17083

Hersford

From: Drew, Scott <sdrew@dtsfluidpower.com>
Sent: Friday, June 16, 2017 2:05 PM
To: patrick.t@lenco-harvesters.com
Cc: Eldridge, Justin
Subject: Summerize Bin Boom

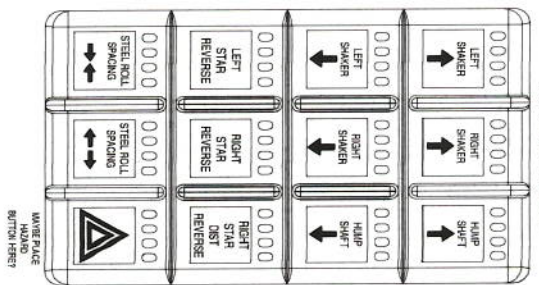
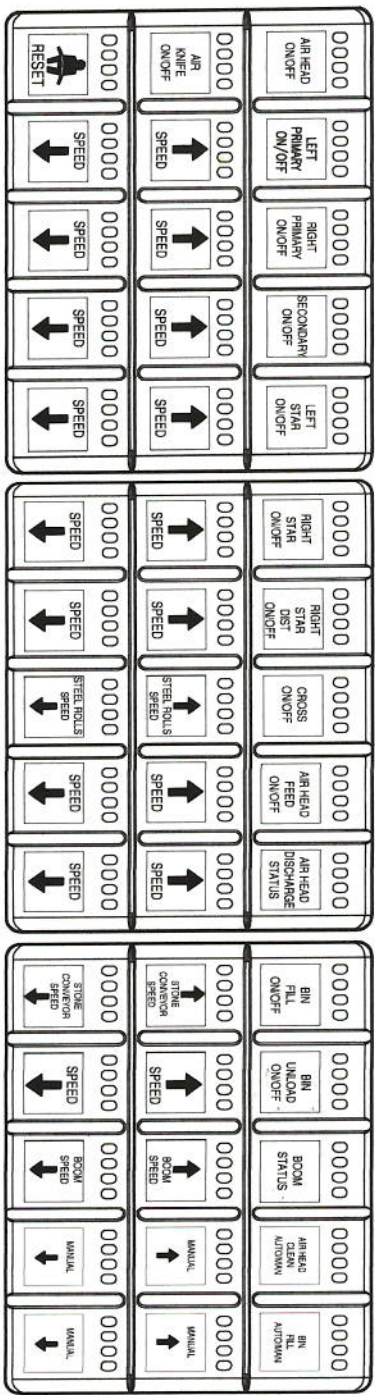
Joystick - Boom Button - Should control the DTS-0373 main circuit solenoid
Momentary Side Pod Button programmed as Latching On/Off, setup as a direct input controls output, not affected by master. The status is setup to be displayed via the LED on the Keypad Boom Status.

Keypad - Bin Unload On/Off - - Should control the SV3-16 Solenoid valve
Keypad button is programmed as latching On/Off, setup to operate with the Boom function, not affected by master. Status is setup to be displayed via the LED on the Keypad Bin Unload On/Off

"Bin Unload On" And "Boom On" = Center Controller Connector 2 Pin 24 Energized (SV3-16 Solenoid valve Actuated, Blocking flow causing the Bin Unload conveyer to run)

Bin Unload On Function will still be active in the controller when the Boom is turned off, but the output to the SV3-16 Solenoid will be de-energized, waiting for the Boom to Be active again.

*SWAP ORANGE #50 PIN 18/31 REAR ENCLOSURE WITH WHITE #04
PIN 24/31 "CENTER CONNECTOR 2" CENTER ENCLOSURE*
